OCEAN GATEWAY GARAGE

PROJECT: DRAWING TITLE:	GATEWAY GARAGE BRICK PAVING REVISIONS	DATE: NOV 16, 2007 REV 6-12-08	CARROLL ASSOCIATES Landscape Architects 75 Market Street Portland, ME 207.772.1552 207.772.0712 (F)	SHEET NO. LSK-1P
		SCALE: 1" = 20'-0"

1 TYPICAL RUNNING BOND PATTERN

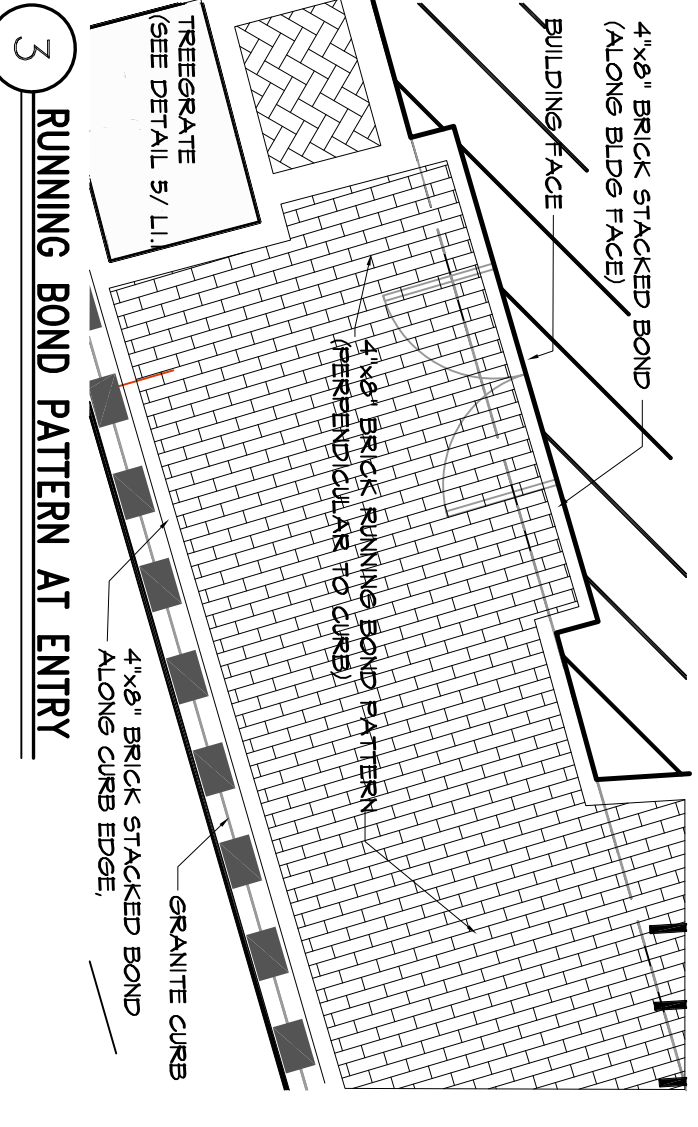
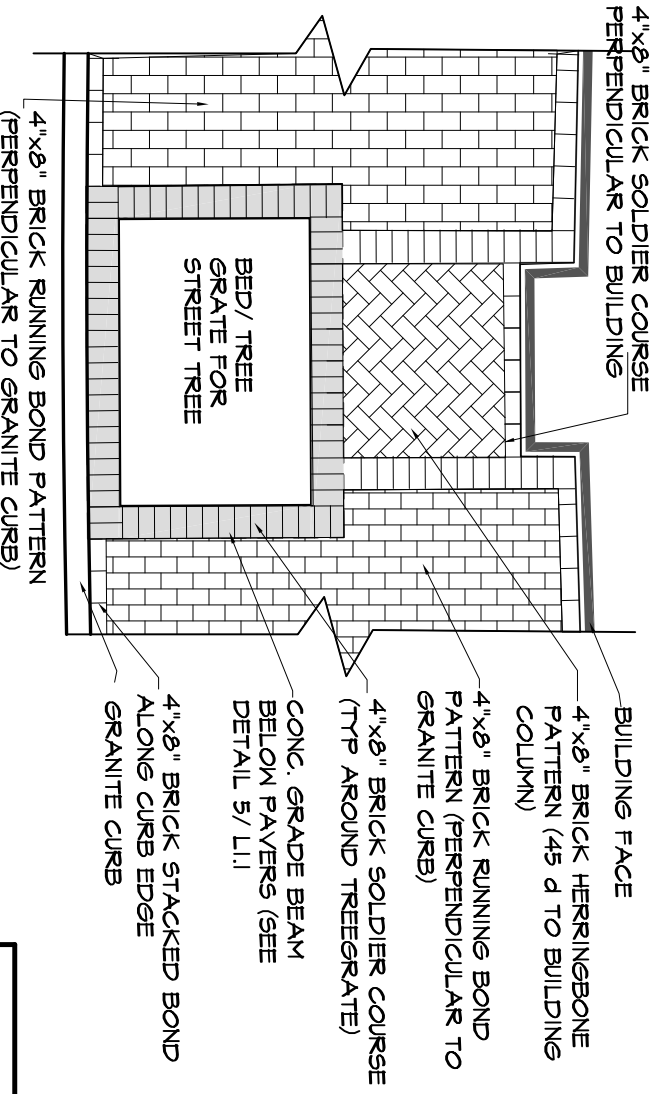
NOTE:
 RUNNING BOND PATTERN NEEDS TO BE PERPENDICULAR TO CURBLINE. BRICKS WILL NEED TO BE MITERED TOWARDS BACK OF WALKWAY AGAINST BUILDING TO COMPENSATE FOR TIGHTER RADII. LARGE GAPS BETWEEN PAVERS AND SMALL WEDGES WILL NOT BE ACCEPTABLE.
